**STAFF REPORT: NOVEMBER 16, 2022 MEETING**  
**APPLICATION NUMBER: 23-8244**  
**ADDRESS: 2475 CHICAGO**

**HISTORIC DISTRICT: BOSTON-EDISON**  
**APPLICANT: MARTIN LEGER, CENTRAL DWELLINGS, CORP.**  
**PROPERTY OWNER: MARTIN LEGER**  
**DATE OF PROVISIONALLY COMPLETE APPLICATION: FEBRUARY 13, 2023**  
**DATE OF STAFF SITE VISIT: OCTOBER 25, 2022**

**SCOPE: REPLACE WOOD WINDOWS WITH ALUMINUM-CLAD WOOD WINDOWS,**

*Applicant photos. Rear elevation, first floor.*

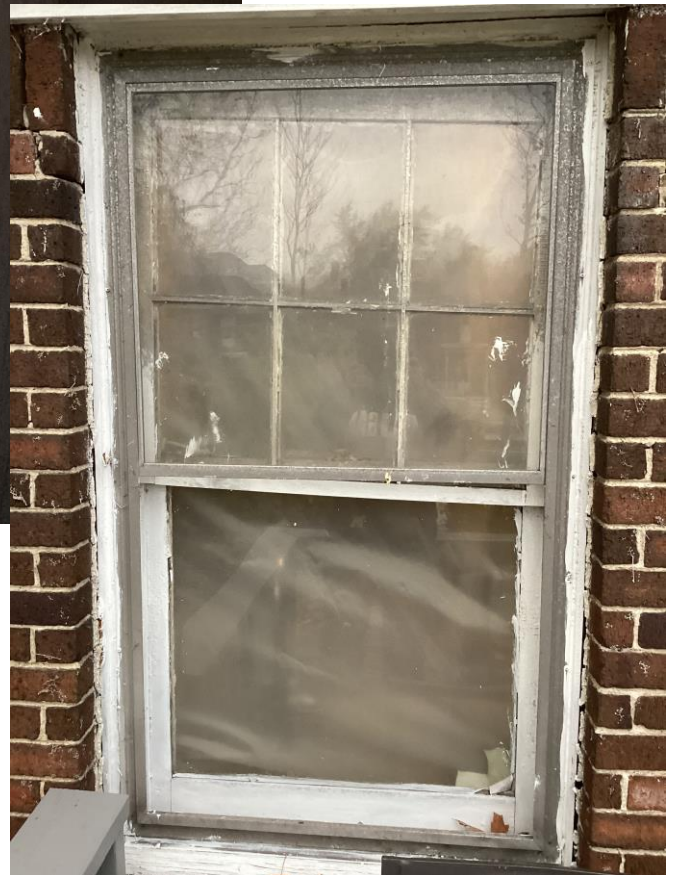
- It is staff’s opinion the photographs submitted by the applicant do not demonstrate that the windows are beyond repair. The frames need to be scraped and painted, and some wood filler/putty may be needed. Most of the openings have storm windows in place, sash are intact (understanding an occasional glass panel was broken), and appear dry.

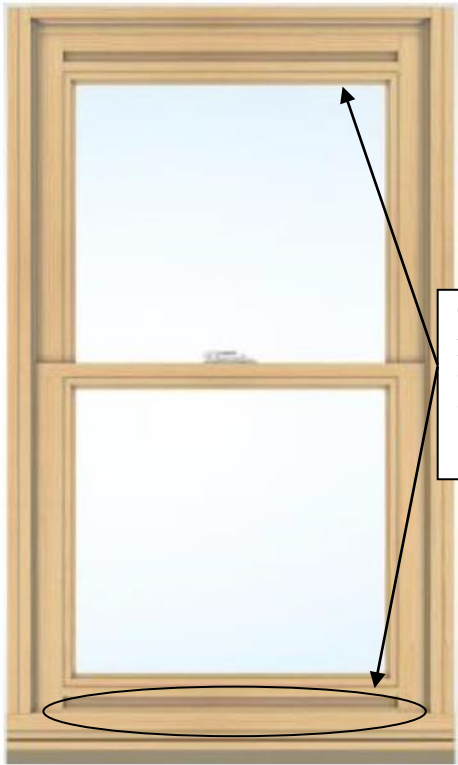
- Even though the measurements of the proposed window units are likely close to the existing wood frames, the dimensionality, materiality, and remaining details of the proposed units offer a significant contrast to the existing windows.

The top and bottom rails have inset areas within the framing to operate the upper and lower sash.

It appears as though this window line is fabricated with an integrated brick mould, which is flat in profile. This integrated unit doesn't offer the opportunity for an alternate trim color, which is common on historic structures.
